HIACE

OUTLINE OF NEW FEATURES

The following changes have been made for the new HIACE.

Rear Leaf Spring

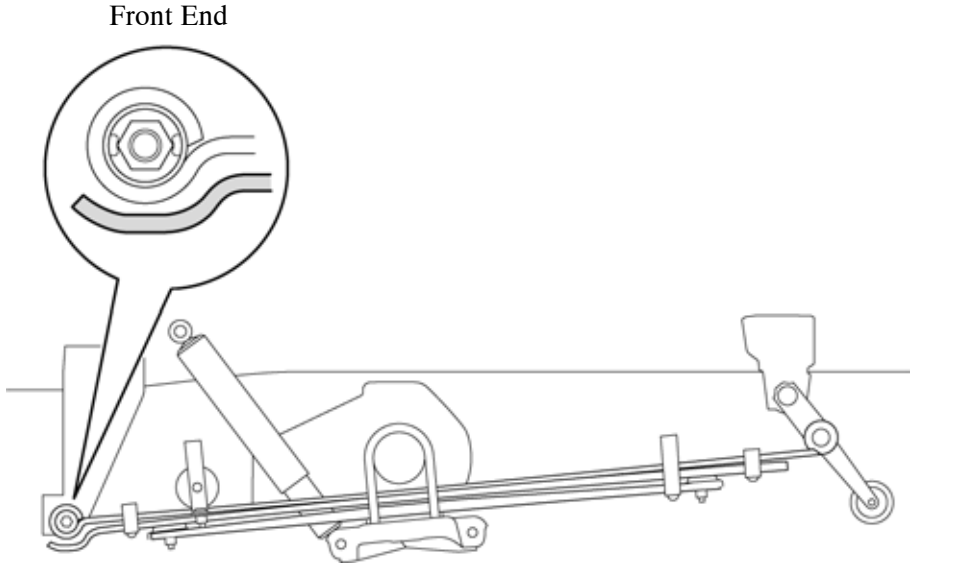
The shape of the front end of the rear leaf springs has been changed for all models.

Front Seat **Rearmost Row of Rear Seats**

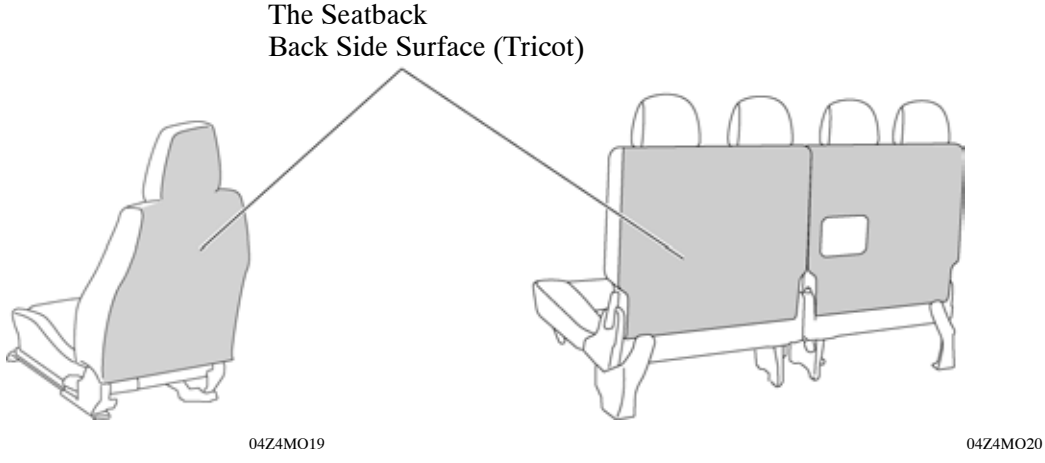
- With the exception of the main section of the seats of the GL grade Commuter models, the surface color of the front/rear seats has been changed from gray to dark gray for all models.
- The surfaces of the back of the seatbacks of the front seats of the DX grade models (excluding PVC leather specification models) and the rearmost row of the rear seats of the Commuter models have been changed from needle punched carpet to tricot.

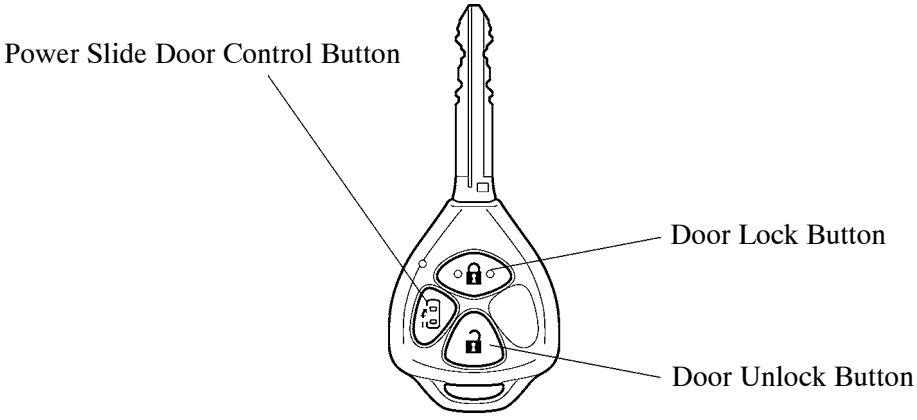
The audio head unit and speakers have been changed. For details of the audio system, see page 57.
